State of New Mexico
Energy, Minerals and Natural Resources Department

7. Lease Name or Unit Agreement Name
State "36"

SUNDRY NOTICES AND REPORTS ON WELLS
(DO NOT USE THIS FORM FOR PROPOSALS TO DRILL OR TO DEEPEN OR PLUG BACK TO A DIFFERENT RESERVOIR. USE "APPLICATION FOR PERMIT" (FORM C-101) FOR SUCH PROPOSALS.)

2. Name of Operator
Mitchell Energy Corporation

MILLER EVERETT
SHEC 36 (A)
B, 36-19-21

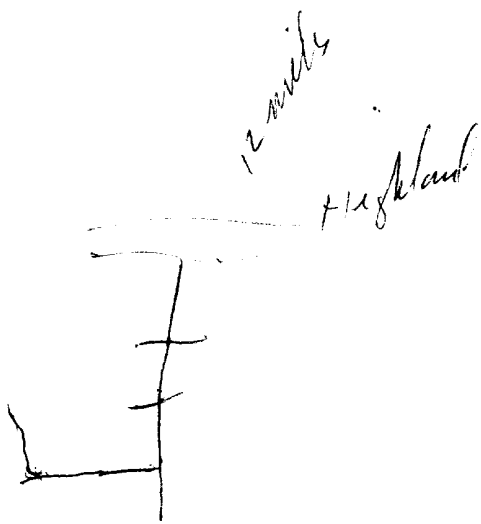
* Tag Stub Plug

Notify N.M.O.C.C. in sufficient time to witness

need not tag if hole
stop full.

need not tag if hole
stop full.

CIAP @ 4280, 35'
~~25 SXS @ 4850'~~ (N + WC)
